Date	Group	No.	Release	Page
1.2012	258	031	1	1(5)

## Diesel Exhaust Fluid (DEF) Tank Harness Bracket and Routing VN, VHD, VAH

### FSB 258-031, DEF Tank Harness Bracket and Routing

W3071686

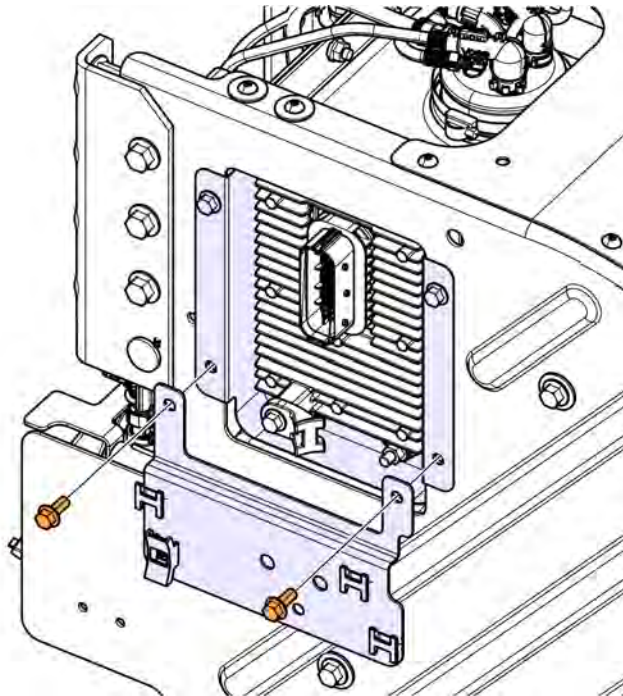
On certain Volvo vehicles built before February 13, 2012, the front chassis to urea tank connection, located on the side of the def tank, may rub the mounting bracket or not stay secured to the mounting bracket. This can lead to electrical faults or corrosion of the connections. Use the following procedure to relocate and to provide a better mounting of the connector and harness.

- 1 Remove all cables from ground (negative) battery terminals to prevent personal injury from electrical shock and prevent damage to electrical components
- 2 Cut cable ties as needed to loosen the DEF harness and connector
- 3 Remove the two lower fasteners which secure the After Treatment Control Module (ACM) and the "L" bracket to the DEF tank. Discard the L bracket.
- 4 Install the new bracket into position on the DEF tank. Secure fasteners and tighten to  $24 \pm 4$  Nm ( $18 \pm 3$  ft-lb)

W3071684

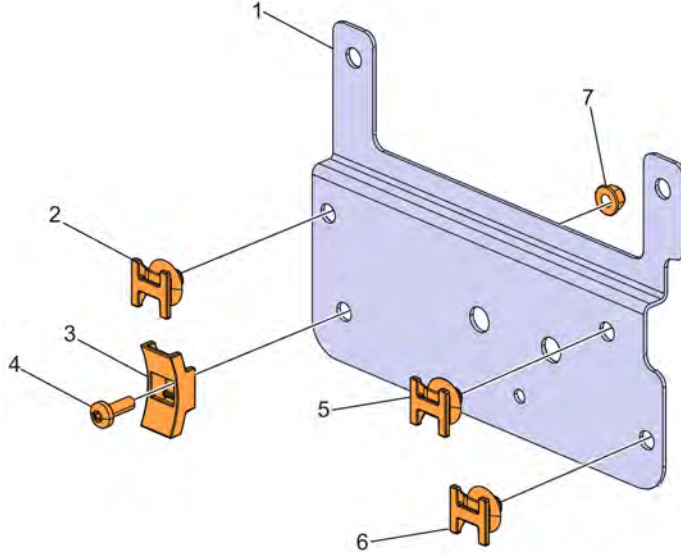
5 Install the fasteners (3 push-in retainers, 1 saddle retainer) onto the new mounting plate

W3071686

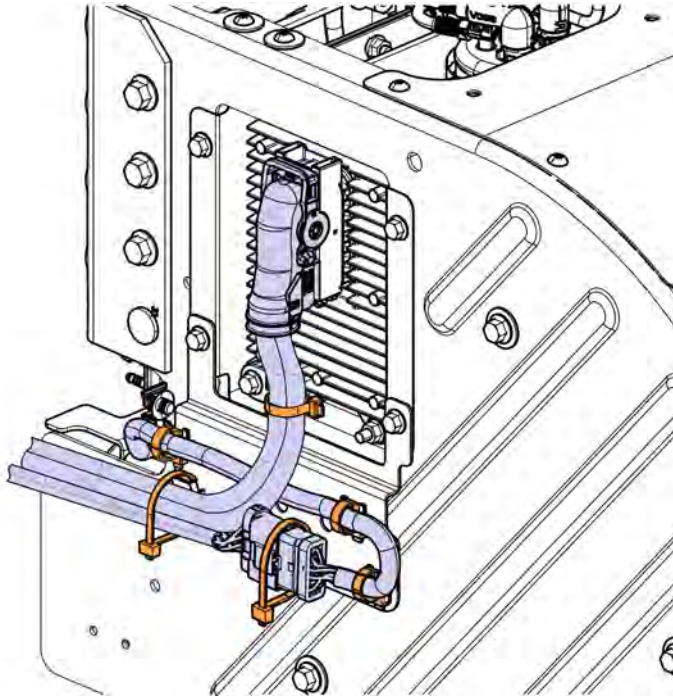
- 6 Route and secure the DEF harness to the bracket with cable ties as shown in illustration. Route the connector cable tie through existing holes in the bracket.
- 7 Route and secure the ACM breakout to bracket with cable ties as shown in illustration

**Note:** Ensure that the harness and connectors are retained and do not make contact with the bracket causing rubbing.
